T10/04-029r2, SAS-1.1: Close Port Selector Detection Gap

To: T10 Technical Committee
From: Robert Sheffield (Robert.L.Sheffield@intel.com), Intel Corporation
Date: May 12, 2004
Subject: T10/04-029r2, SAS-1.1: Close Port Selector Detection Gap

Figure 90 — XL (link layer for expander phys) state machine (part 1)

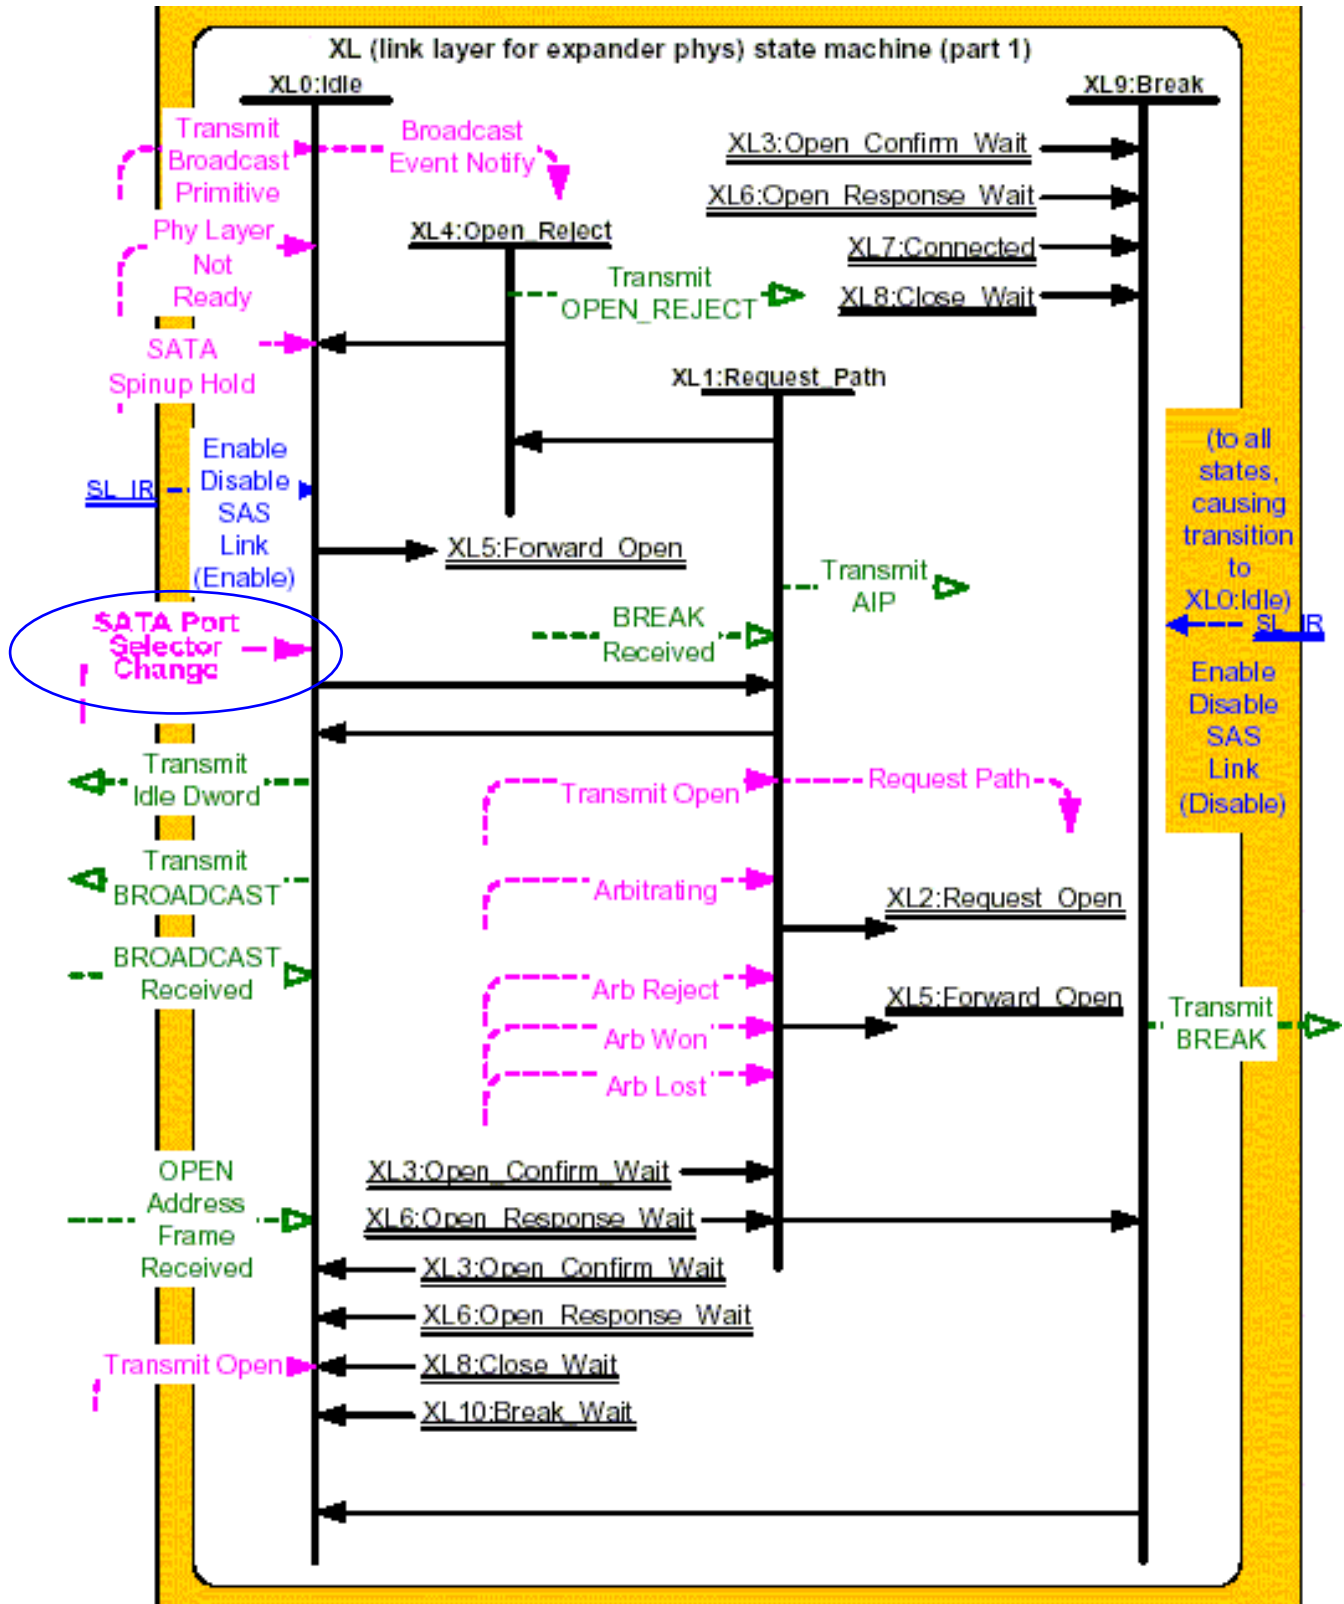
Modify figure 90 in subclause 7.15.1 as follows:

If a SATA Port Selector Change confirmation is received, this state shall send a Broadcast Event Notify (SATA Port Selector Change) request to the BPP.
